New Century Hall, NOMA - Listed Building Consent Ref Ref. 130704/JO/2021

Variation of Condition Application - Tenant Fit Out

(Left, showing original demolition of the slab on the ground floor GA; right, the proposed location of the dumbwaiter at basement level).

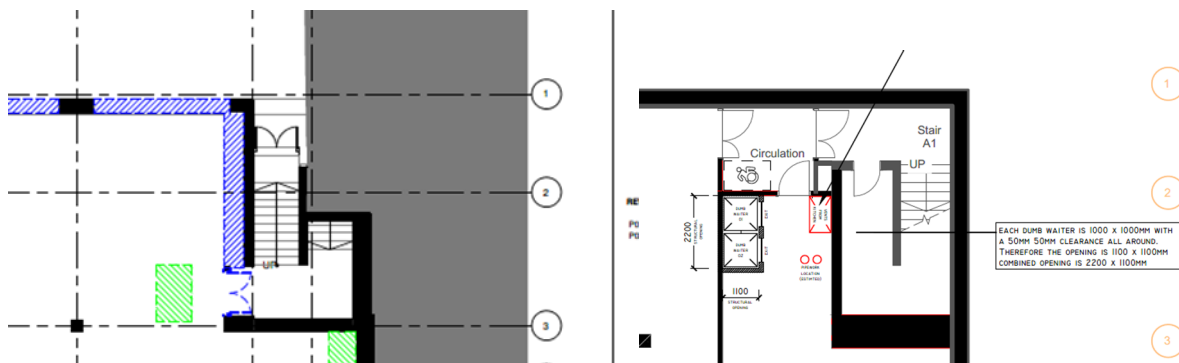
1.2 Dumbwaiter Location

It is proposed to slightly move the dumbwaiter and associated slab demolition, the size of the slab demolition remains unchanged. This will see the location of the dumbwaiter move from gridline 3 to gridline 2 and which does not impact on any of the waffle slab within the basement ceiling. The change will provide an improved and more practical layout for the kitchen facilities.

Figure 1: Ventilation openings – basement level (extract from drawing 4021-F00-008)

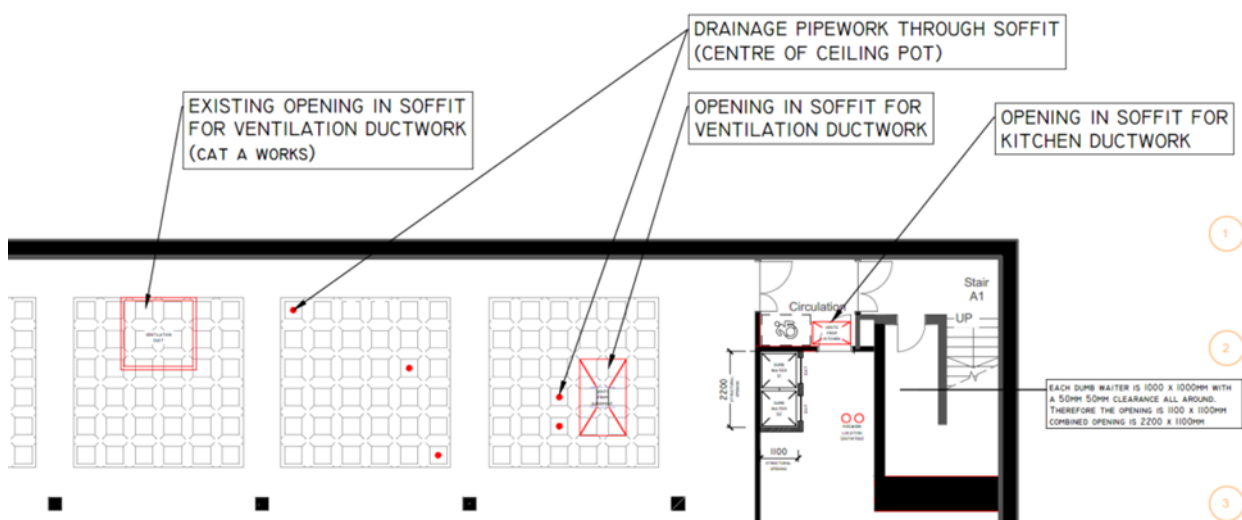
The tenant has undertaken a review of the air conditioning and ventilation requirements of the building. As such the location of the servicing penetration for the ventilation is now known. These are shown between basement and ground level within grid lines K and L, as shown on drawing 4021-F00-008, and have been positioned within the zones highlighted within the Tenant Fit Out Guide for allowable positions for service openings (Figure 2). The service opening is necessary for the provision of fresh air and extraction of stale air to facilitate the occupation of the basement area for College use.

Careful consideration has been given to location of the penetration through the floor slab so this will be aligned with one of the extract louvre grilles on the elevation to Miller Street, within the external plant compound area where permission has previously been granted as shown on drawing Nr NCHA-SRA-ZZ-XX-DR-A-20827.

An additional service opening is proposed within the floor slab to service the basement (College) kitchen extract, which is shown on drawing 4021-F00-008 (Figure 1) positioned adjacent to stairwell A1 within the circulation space. The opening through the slab is not positioned within the agreed tenant fit out zones (Figure 2) and therefore 4021-F00-008 drawing has been provided to reflect this proposed modification. This is necessary in order to align with the uses on the ground floor W1707-203-Rev B and will sit within the steel framework required for the dumbwaiter opening. By locating these adjacent to each other will result in one area of opening and associated steel work.

Figure 2: Tenant fit out guide - Ground Floor Food Hall Service Penetration Zones

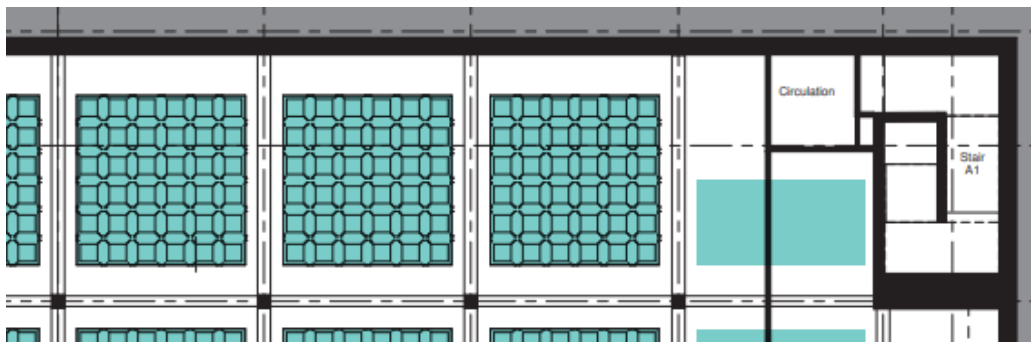
Service penetration zones for pop ups to serve Food Hall above
Maximum 45no. penetrations at any one time.

Figure 3: External Extract louvre - Ground Floor level (extract from QS4669/JH/M02)

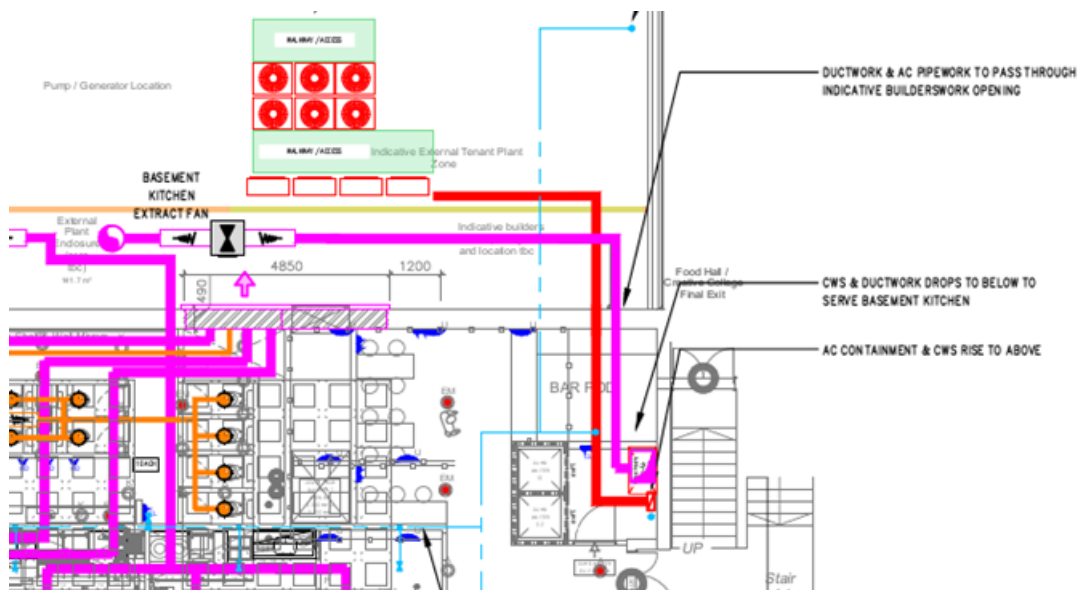
As shown on drawing QS4669/JH/M02 (Figure 3), a corresponding external extract louvre is proposed to the Miller Street elevation at ground floor level for the kitchen extract again between grid lines L and M. This louvre will be in lieu of the previously proposed small square section extract louvre shown on drawing NCHA-SRA-ZZ-XX-DR-A-20827 between grid lines J and H. The louvre will be positioned so this is screened from road level by the perimeter wall to the plant compound.
